### **CONCEPT PLAN REVIEW: ASPEN CHAPEL HILL (Project #21-012)**

**SUMMARY REPORT**

# **Aspen Chapel Hill**

**Mobility & Connectivity Plan (Excerpt)**

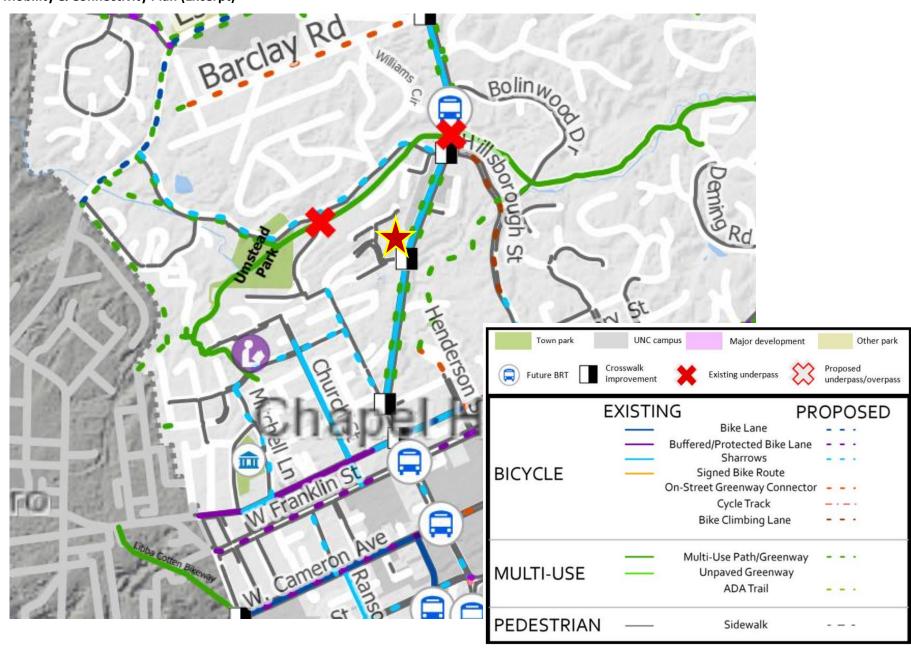
- The site is located along Martin Luther King Jr. Blvd. just north of East Longview Street. There are existing sidewalks and sharrows along Martin Luther King Jr. Blvd.
- Future Bus Rapid Transit stations are located within ½ mile of the site. The applicant should coordinate with Chapel Hill Transit for the latest information on BRT design, station locations and any potential connections.

# Parks Comprehensive Plan (Excerpt)

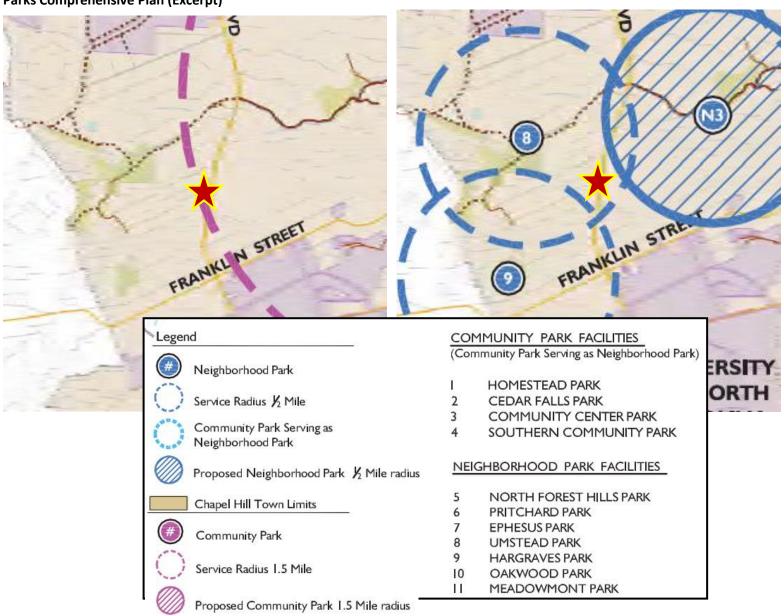
- The site falls in the Neighborhood Park Service Radius of Umstead Park, and in the Community Park Service Radius of the Community Center Park.
- No additional Neighborhood Parks or Community Parks are proposed in this area.

**Greenways Master Plan (Excerpt)**

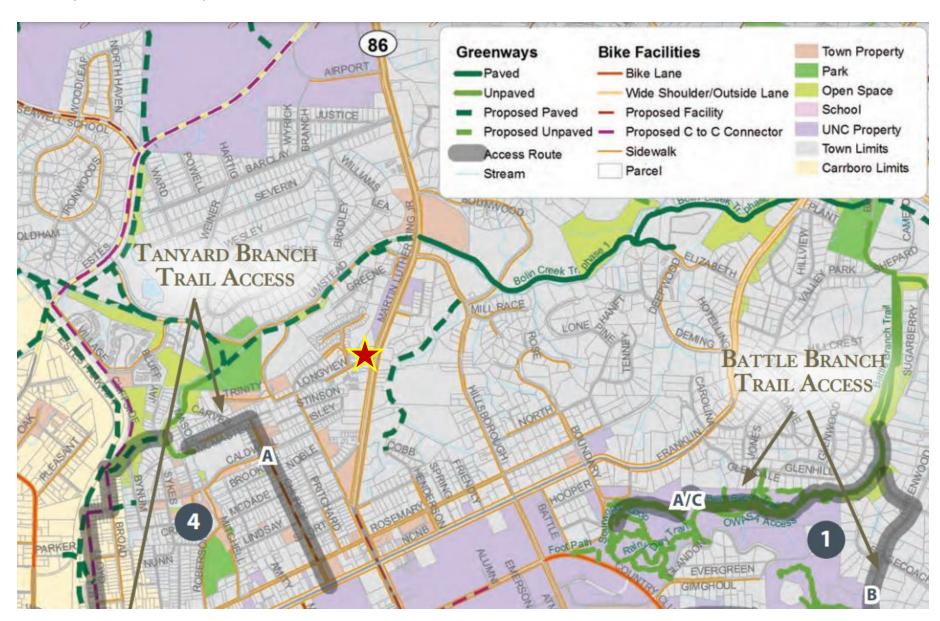
There are no proposed greenway facilities impacting this site.
